Official Recall Notification U.S. Federal Boat Safety Act - 25/30 HP EFI FourStroke Motor Mount Retaining Nuts

Please contact your Mercury Outboard dealer and mention Service Bulletin 2007-21 to schedule an appointment to have this inspection performed on your outboard. Your dealer will be able to determine how long this inspection/correction will take.

18793

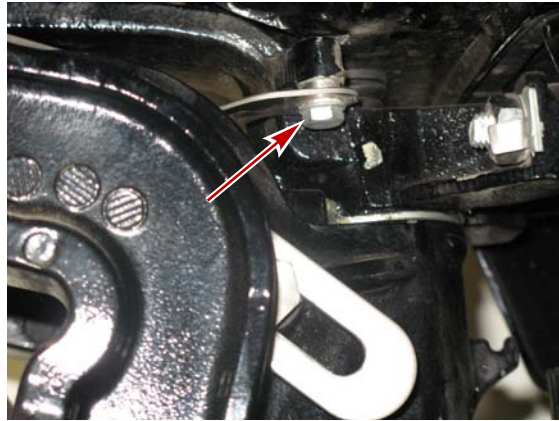
1. Bend the tab of the locking plate away from the upper motor mount retaining nut.

33407

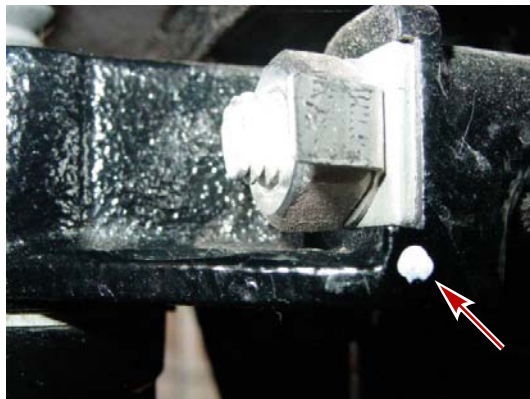
- Apply the specified amount of torque to the mount retaining nut. If the flat of the nut does not align itself with the tab of the locking plate, continue to tighten the nut until alignment occurs. Be sure the locking plate does not move while the specified torque is being applied.

Description	Nm	lb. in.	lb. ft.
Mount retaining nut	35		26

- Reposition the tab of the locking plate against the flat on the nut. Flatten the tab against the nut with a flat punch.
- Apply a white paint dot, in the area shown, to identify that the repair has been performed.
